## OR-8 ROAD SAFETY AUDIT Tualatin Valley Highway at SW 185<sup>th</sup> Avenue

Mile Point 6.45 – 6.73

Road Safety Audit (RSA)

January 31, 2012

**Exhibit B – Crash Diagram (OR-8 & SW 182<sup>nd</sup> Ave)**

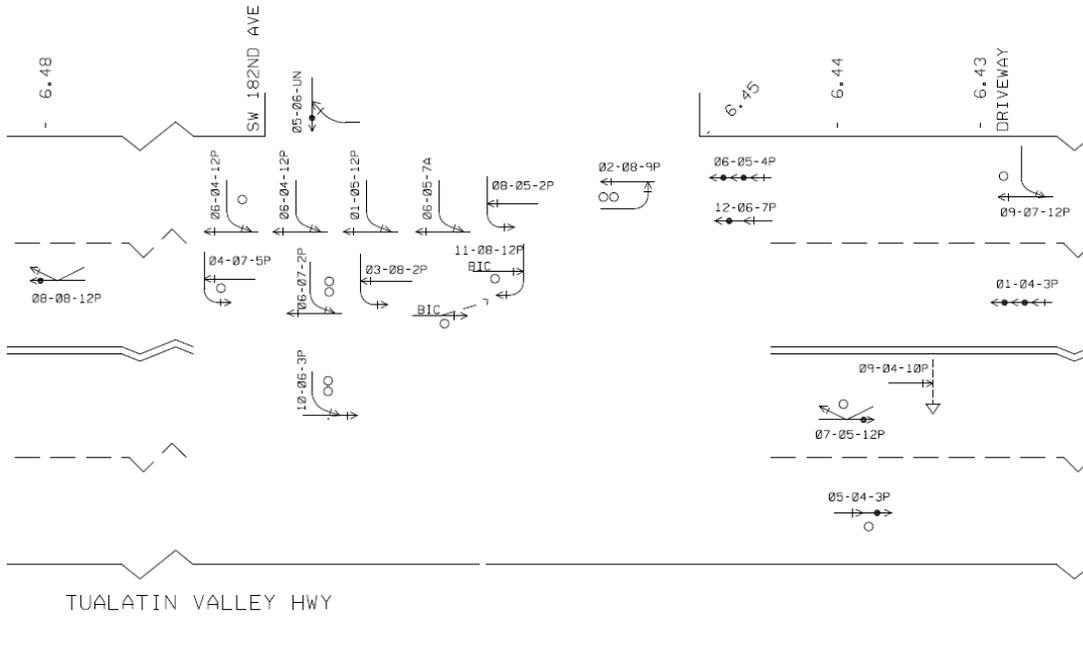
The crash diagram of the corridor was also reviewed. Focus was given to the intersection of OR-8 and SW 182<sup>nd</sup> Ave, where many serious crashes occurred (see Exhibit B below). This T-intersection is within the influence area of the signalized SW 185<sup>th</sup> Ave intersection to the west. The entire crash diagram for the section is included in Appendix A.

- Heavily congested intersection
- The most serious crashes occurred at SW 182<sup>nd</sup> Ave and SW 187<sup>th</sup> Ave from left-turn movements
- Many incidents due to left-turn conflicts at accesses
- Not many crashes within the SW 185<sup>th</sup> Ave intersection
- Number of crashes probably under reported
- Most pedestrians on SW 185<sup>th</sup> Ave
- Many jaywalkers
- Likely increased driver frustration/agitation due to proximity of schools

Restricted sight distance at SW 187<sup>th</sup> Ave.

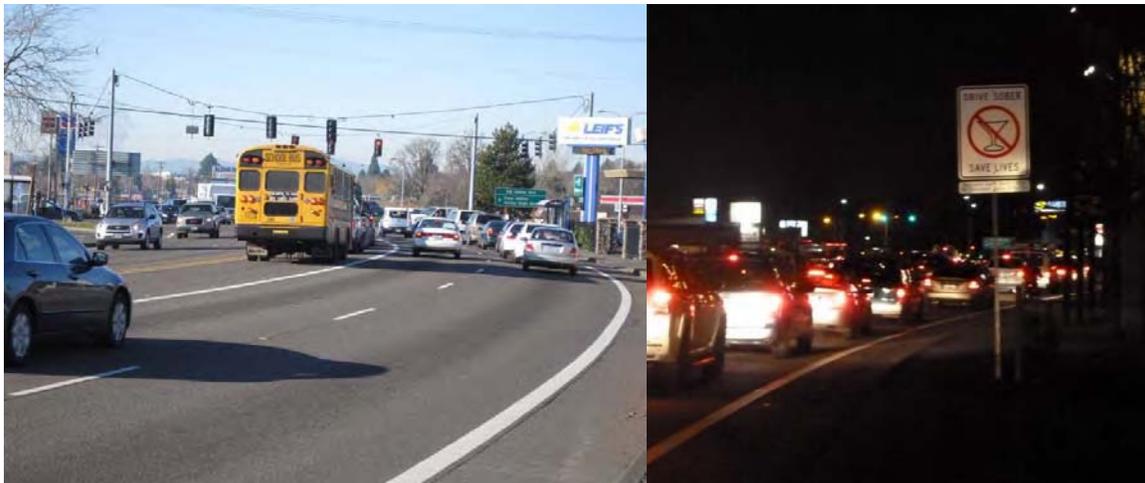
Visibility for roadway users is limited or compromised in several locations. Views are diminished by vegetation near the northbound slip lane on SW 185<sup>th</sup> Ave and at the Aloha Mall accesses on the north side of the highway to the west of SW 185<sup>th</sup> Ave. At least one business was observed to have a portable sign near a driveway that limited the view of exiting motorists. Large parked vehicles in the Aloha Mall parking lot limit intersection sight lines at SW 187<sup>th</sup> Ave.

Examples of sight distance restrictions in study area.

- Consider relocating portable signs and maintaining vegetation to improve sight triangles consistent with county ordinances or state highway access permits. RSA team recommends addressing in an ongoing fashion.

South crosswalk at SW 185<sup>th</sup> Ave.

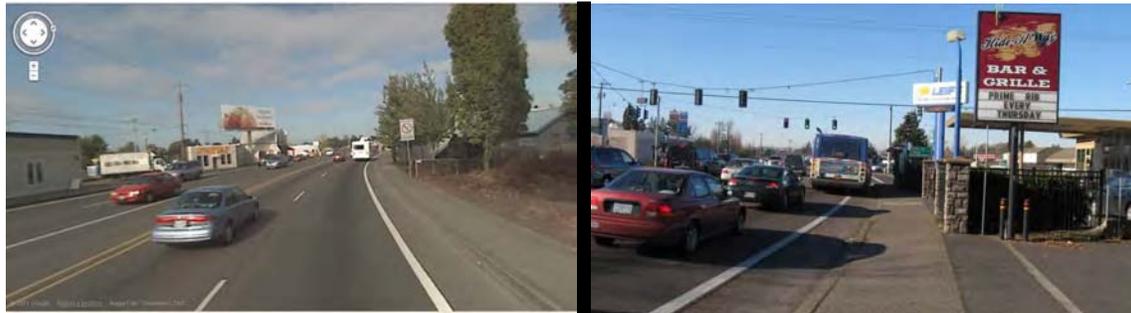
The approaches and intersection of SW 185<sup>th</sup> Ave and TV Highway are currently not illuminated. There are numerous conflicts created by driveways, bus stops, pedestrian crossings, and the traffic signal operation. The conflicts may not be as readily apparent under ambient light or vehicle headlights. Drivers may have reduced time to react to conflicts. The lack of illumination may contribute to a failure by drivers to recognize the changing roadside character of the area.

South crosswalk of SW 185<sup>th</sup> Ave  
Left turning vehicle crossing pedestrian path.  
Note: picture brightened to show conflicts

- Consider installing illumination along TV Highway from SW 182<sup>nd</sup> Ave to SW 187<sup>th</sup> Ave.

Northbound right turn slip lane.

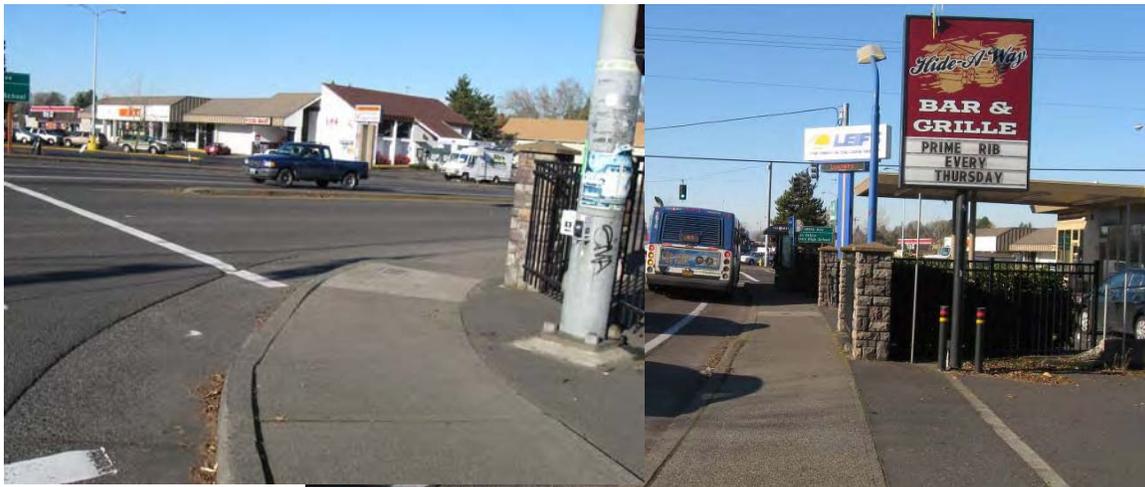
Current geometry of the northbound right turn slip lane results in diminished scanning behavior and varying points where motorists stop before entering TV Highway. The design of the slip lane encourages higher speeds and unpredictable driver behavior that presents additional safety concerns related to pedestrian movements across the slip lane. Numerous crashes (especially rear-ends) have been linked to the operation of the northbound right turn slip lane.

- Consider reconstructing the northbound right turn slip lane with improved geometry:
  - Consider a 2:1 length to width ratio for the island, consistent with guidance in the Oregon Bicycle and Pedestrian Design Guide and the ODOT striping manual.
  - Alternatively, consider replacing the slip lane with a traditional right-turn lane.
- Consider enhancing crosswalk with continental-style markings.
- Consider improving geometry of southbound left turn. The operation of the slip lane could likely be improved by pulling back the stop bar for the westbound left turn. This would better facilitate southbound left-turning motorists using the inside lane as they complete their turns.
